International Aero Engines

SERVICE BULLETIN

STARTING - INTRODUCTION OF A STARTER INCORPORATING IMPROVED CLAMPING OF THE TURBINE ASSEMBLY (L7), INCREASED OIL FLOW (L9) AND ADDITIONAL OVERFLOW TUBE (L10) - CATEGORY CODE 6 - MOD.ENG-80-0005

V2500-ENG-80-0005

Modification of Bearing Spacer Figure 1

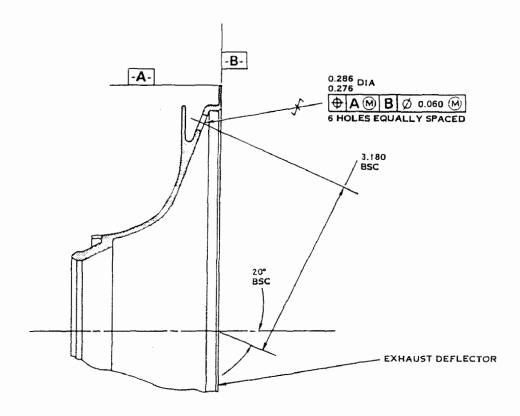
- (b) Modify two bearing spacers PN 797632-1 to PN 797632-2 as follows:
 - Machine four additional 0.210 to 0.216 inch diameter holes, locating these holes equally spaced from existing four holes for a total of eight equally spaced holes as shown in Figure 1.

- Break edges 0.025 inch (MAX) on ID and OD of drilled holes.
 - Reidentify modified bearing spacers PN 797632-1 to PN 797632-2 by bagging or tagging as PN 797632-2. Do not physically mark part number on spacers.

Modification of Exhaust Deflector Figure 2

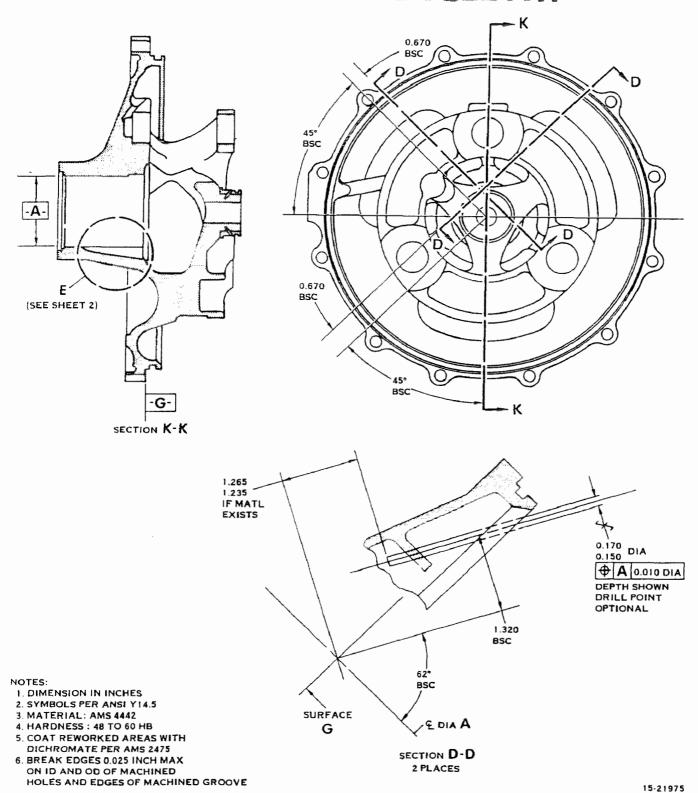
- (2) Modify exhaust deflector PN 792995-2 to PN 792995-3 as follows:
 - (a) Machine six 0.276 to 0.286 inch diameter holes equally spaced as shown in Figure 2.

- (b) Break edges 0.025 inch (MAX) on ID and OD of machined holes.
 - (c) Reidentify modified exhaust deflector PN 792995-2 to PN 792995-3 by X'ing out "-2" and marking "-3" adjacent to the existing part number, using vibration peen or electrolytic etch marking method.

Modification of Gear Cage and Inserts Figure 3 (Sheet 1 of 2)

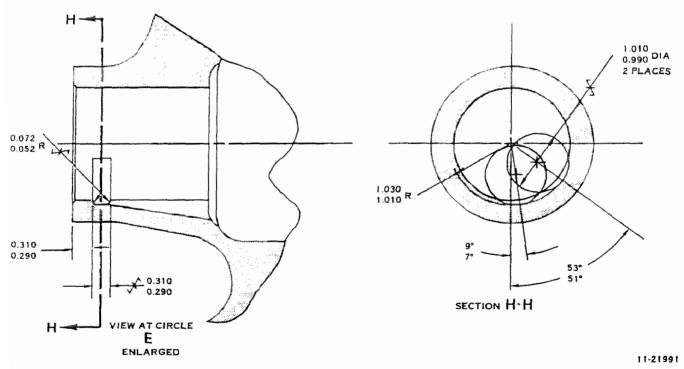
- (3) Modify gear cage and inserts PN 738138-5 to PN 738138-102 as follows:
 - (a) Machine two 0.150 to 0.170 inch diameter holes as shown in section D-D, Figure 3 (Sheet 1 of 2).
 - (b) Machine a 0.290 to 0.310 inch wide groove using a 0.990 to 1.010 inch diameter cutter as shown in view E, section H-H, Figure 3 (Sheet 2).
 - (c) Break edges 0.025 inch (MAX) on ID and OD of machined holes and edges of machined groove.
 - (d) Coat rework surfaces with dichromate per AMS2475.
 - (e) Reidentify modified gear cage and inserts PN 738138-5 to PN 738138-102 by X'ing out "-5" and marking "-102" adjacent to existing part number, using shallow impression marking method.
- (4) Assemble and test pneumatic starter in accordance with existing component maintenance manual.
- B. Reidentification

Pin Installation Deformation Dimensions Figure 1

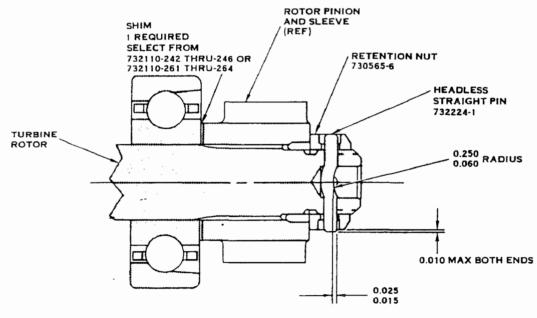
- (3) Assemble rotor balancing assembly in accordance with existing component maintenance manual and the following additional instructions.
 - (a) Install one new solid shim, PN 732110-264 on turbine rotor as shown in Figure 1.

⁽f) Install new headless straight pin, PN 732224-1. Crimp as shown in Figure 1.

Modification of Transmission Housing Figure 1

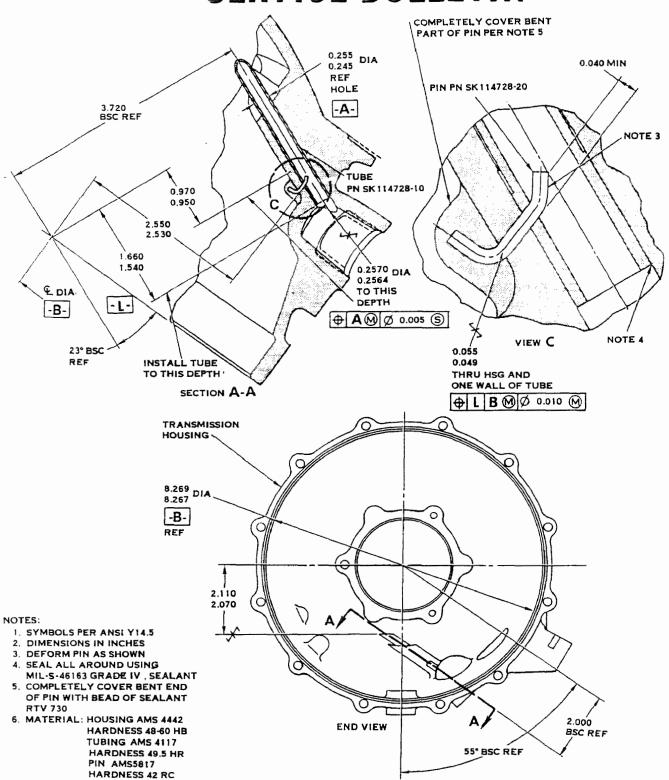
- A. Modify pneumatic starters as follows:
 - (1) Modify transmission housing PN 738274-100 to PN 738274-101 as follows:
 - (a) Machine existing 0.245 to 0.255 inch diameter hole in transmission housing to 0.2564 to 0.2570 inch diameter to depth shown in section A-A, Figure 1.

- (d) Heat transmission housing to 275 to 325 °F and maintain for 1 to 2 hours or chill tubing PN SK114728-10 to -275 to -325 °F.
 - (e) Install tubing into housing until slotted end is at 1.540 to 1.660 inch depth shown in section A-A, Figure 1.

- (g) Prime all around end of tubing where it protrudes through the transmission housing using Primer MIL-S-22473, Grade N, per view C, Figure 1.
 - <u>WARNING</u>: WEAR PROTECTIVE GLOVES WHEN HANDLING HEATED PARTS TO AVOID SEVERE BURNS.

- (h) Apply sealant, MIL-S-46163, Type III, Grade R, all around end of tubing where it protrudes through the transmission housing, view C, Figure 1. Cure at 202 to 222 °F for sufficient time to ensure bondline is at cure temperature for a minimum of 60 minutes. Allow housing to return to room temperature.

- (i) Machine 0.049 to 0.055 inch diameter hole through transmission housing and one wall of tubing, per section A-A and view C. Figure 1.
- (j) Break edges 0.025 inch maximum on ID and OD of machined hole.

- (k) Coat rework surface with dichromate per AMS2475.
- (1) Insert pin PN SK114728-20 as shown in view E, Figure 1 and deform end protruding into tube minimum of 0.040 inch.

- (o) Apply a bead of sealant RTV 730 to completely cover bent end of pin protruding from housing per view C, Figure 1. Air cure at room temperature for minimum of 72 hours.

- (p) Machine end of tubing to 2.070 to 2.110 inch dimension shown in end view, Figure 1.
- (q) Break edges 0.025 inch maximum on ID and OD of machined end of tubing.
